21. TESTING AND COMPUTER CODE EVALUATION

21.1 Introduction

The AP1000 standard design is a two-loop, pressurized-water reactor (PWR) with an electric output of approximately 1,117 MWe. As such, the AP1000 is a passive plant design that represents an evolution from the AP600 design, which has an electric output of approximately 600 MWe and was the first passive, advanced light-water reactor (ALWR) design reviewed by the U.S. Nuclear Regulatory Commission (NRC). These advanced plant designs differ from conventional PWRs in that they use passive safety systems to provide the means to cool the reactor core following an accident. Unlike conventional active safety systems, these passive safety systems use only natural forces, requiring no continuously operating, electrically [alternating current (ac)] powered, mechanical components (such as pumps).

Figure 21.A-1
 AP600 Peak Cladding Temperature Transient for the AP600 $C_D = 0.8$ DECLG Break

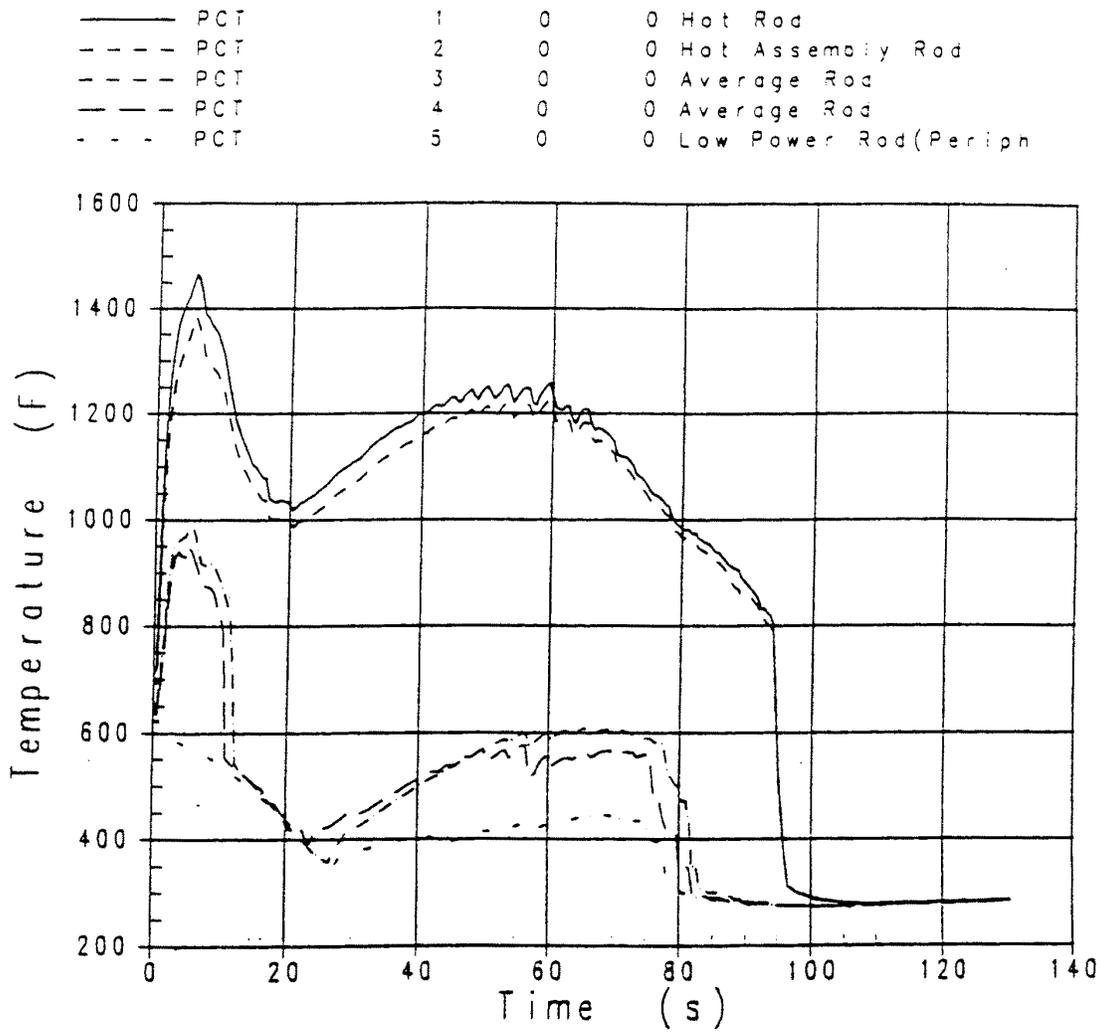
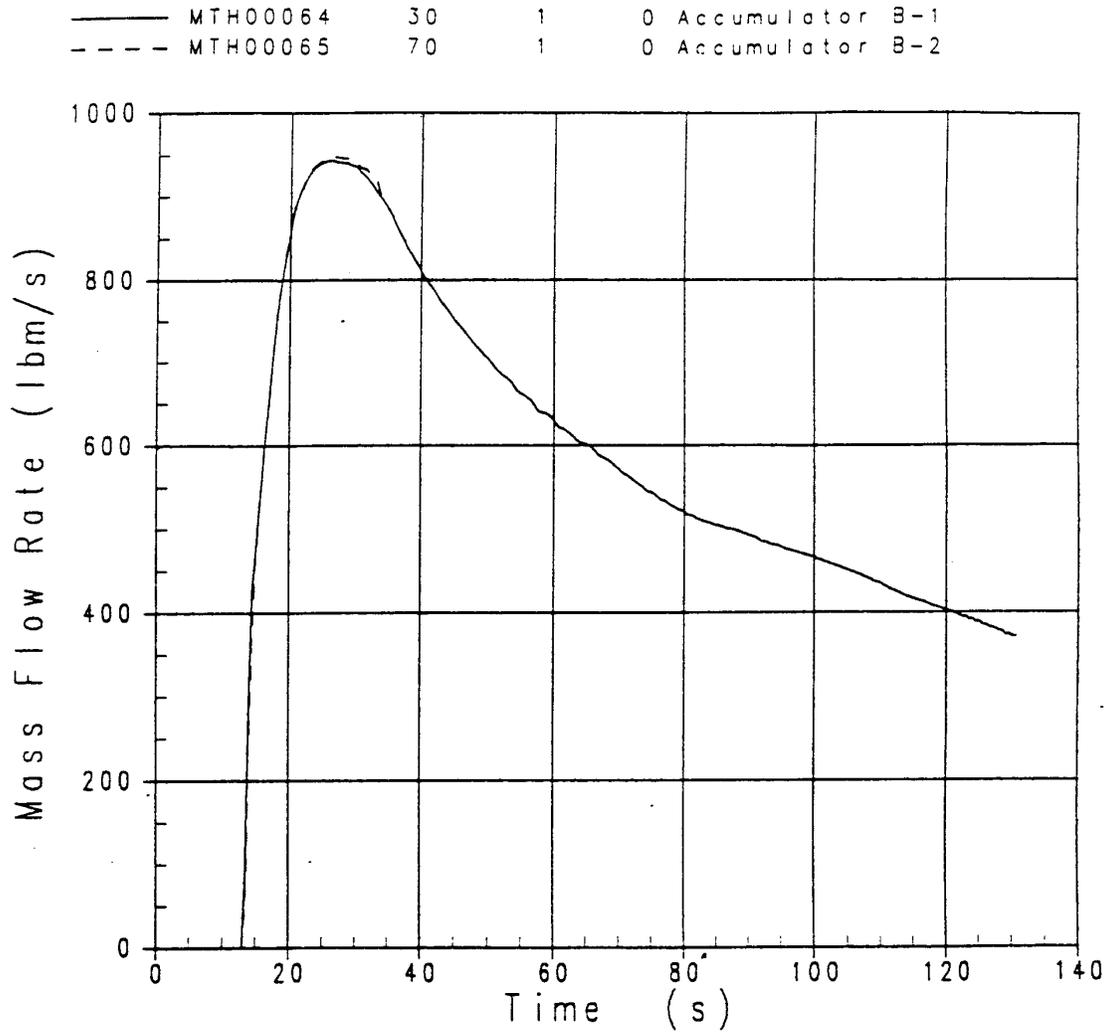
For the AP600, accumulator nitrogen cover gas was not important because the AP600 accumulators do not empty until after the core is completely quenched (see Figures 21.A-1 and 21.A-2 of this report). In addition, on the basis of the applicant's response to comment 1(g) in the letter (NSD-NRC-97-5171) dated June 10, 1997, 60 percent of the initial liquid remains in the accumulators at the time of PCT, so small changes in the analysis results or the AP600 design will not cause the accumulators to empty before the time of PCT. In the approved methodology, the applicant results presented in response to Volume 1, Question 134, of its letter (NTD-NSA-MYY-95-12) dated April 21, 1995, discussed the effects of dissolved nitrogen coming out of solution in the primary system, and the applicant showed that effect was negligible.

The applicant compared the calculated and measured results for a number of parameters. The cladding temperature response is illustrated in Figures 21.A-3 to 21.A-8 of this report. All the

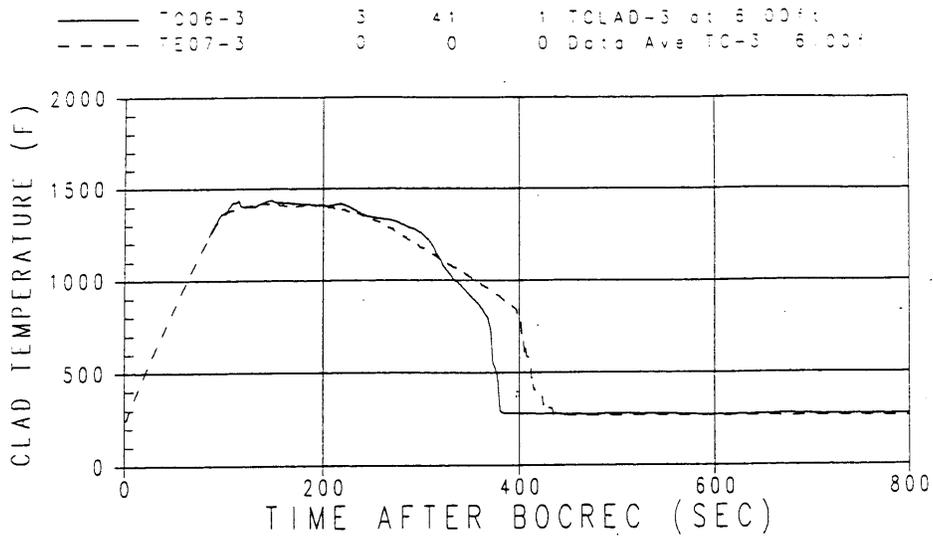
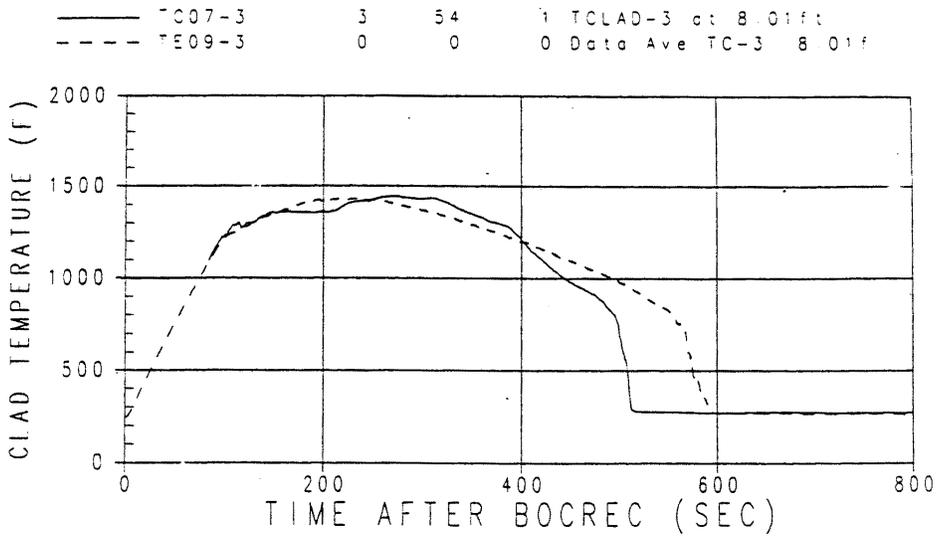
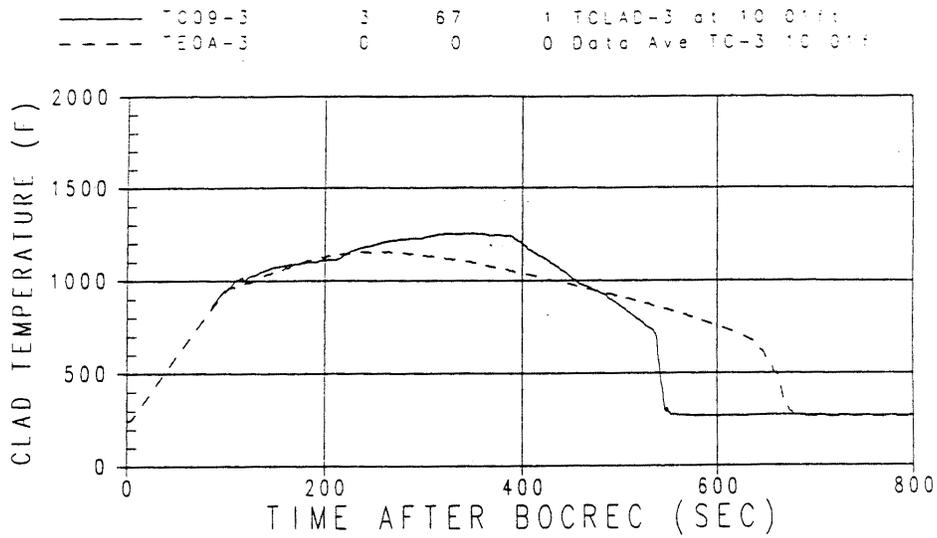
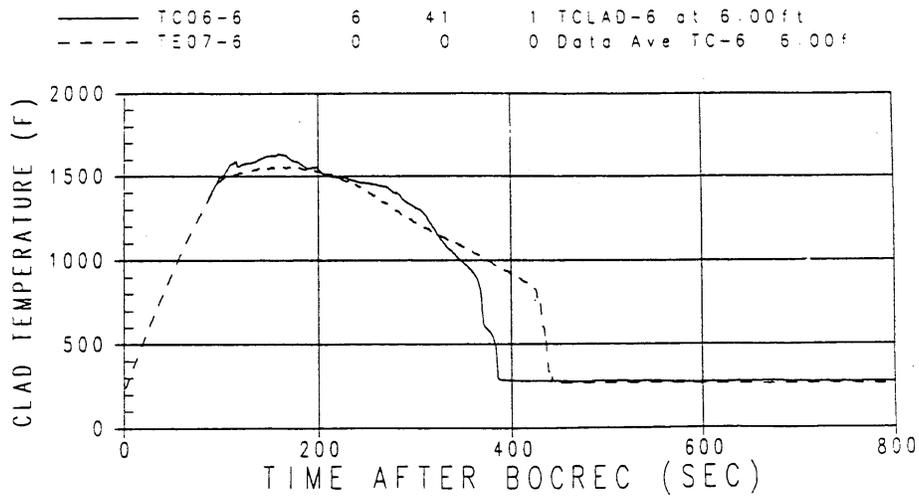
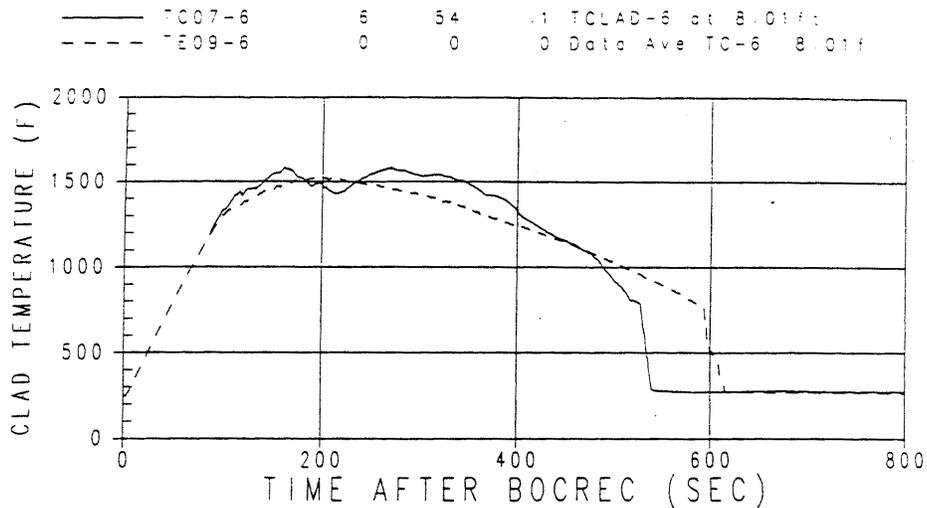
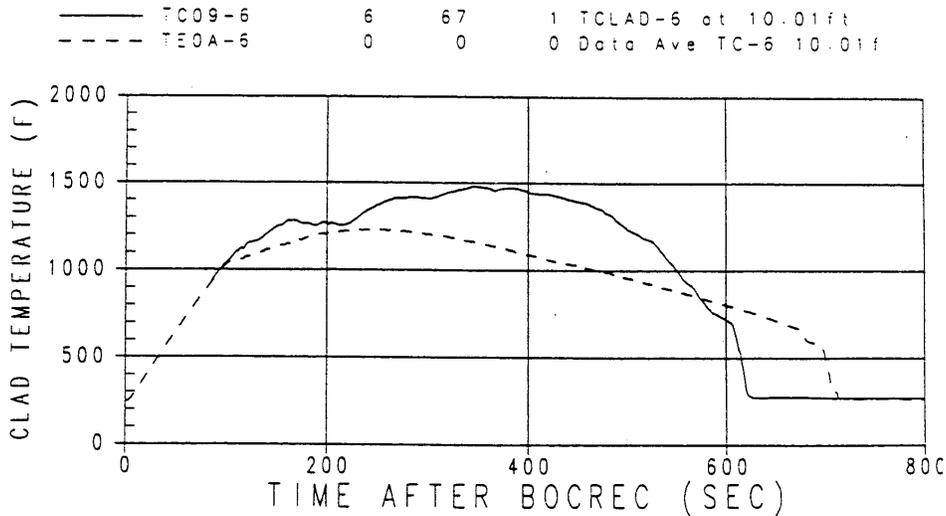
comparisons of cladding temperature response are found in Figures 3.1-16 to -30 of WCAP-14171. The comparisons showed that the calculated results overpredicted the cladding temperatures, with the greatest overprediction coming at the 2.4 m (8 ft) and 3 m (10 ft) elevations. While the cladding PCTs were higher, the calculated cooldown after the PCT was more rapid, and quench times were earlier than indicated by the data (Figures 21.A-9 to 21.A-11 of this report). The applicant attributed the more rapid quench progression in the WCOBRA/TRAC analysis relative to the data to the fact that the calculated results did not show the core/downcomer oscillations observed in the test. As discussed in the applicant's response to comment 8 of its July 18, 1997 letter (NSD-NRC-97-5240), this difference was because of the calculated downcomer level stabilizing below the downcomer injection port, whereas the downcomer level recovered to submerge the port in the test. The lower downcomer level was the result of a small overprediction of entrainment out of the vessel.

Figure 21.A-12
CCTF Run 58, Upper Plenum Pressure Comparison

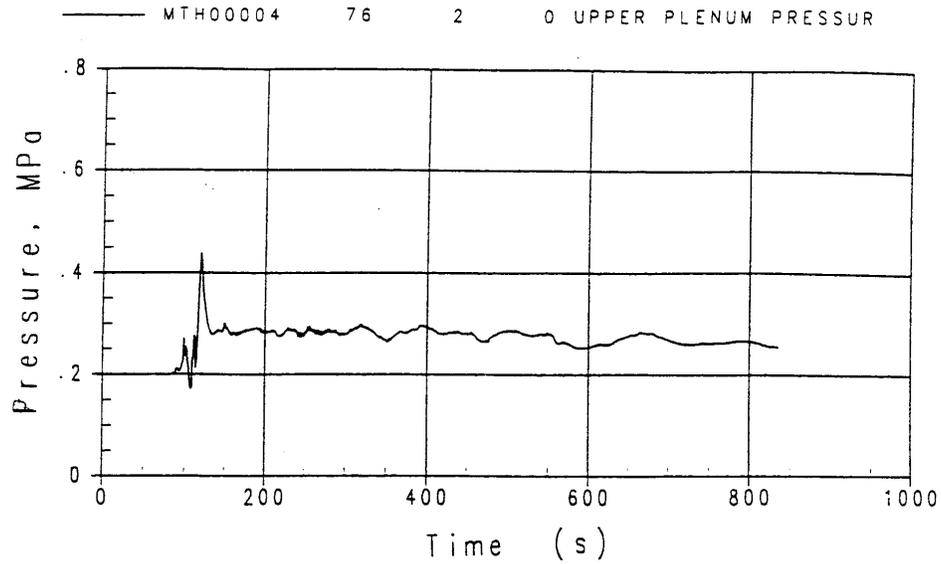
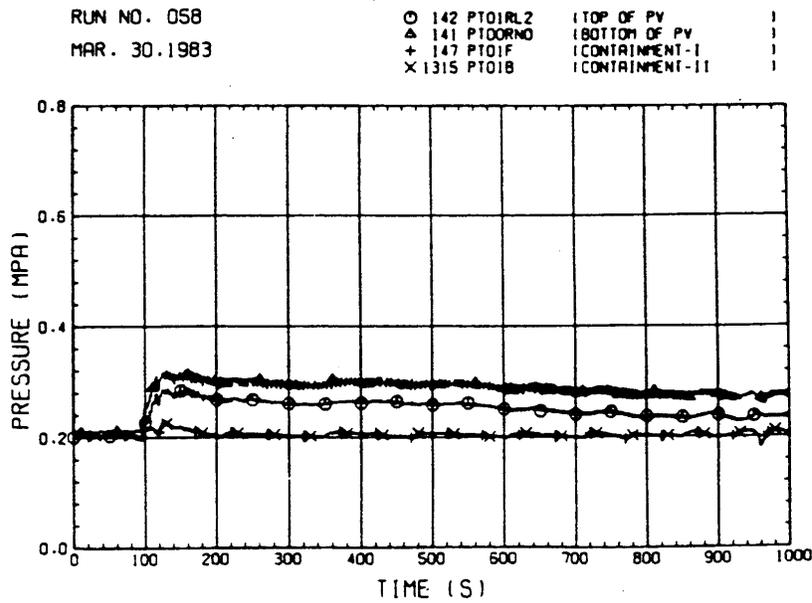
The upper plenum pressure was overpredicted for most of the test (Figure 21.A-12 of this report) because the more rapid quench advancement in the calculation resulted in higher steam production relative to the test. Downcomer and core differential pressure comparisons (Figures 21.A-13 and 21.A-14 of this report, respectively) showed that the calculated downcomer pressure difference was within the band of the oscillations observed in the test, and the measured core pressure difference was well predicted. Regarding loop flows, the comparisons showed that, in general, WCOBRA/TRAC results were relatively close to the test data except for the Cold Leg 1 and Hot Leg 4 steam mass flows, which were overpredicted (Figures 21.A-15 to 21.A-19 of this report).
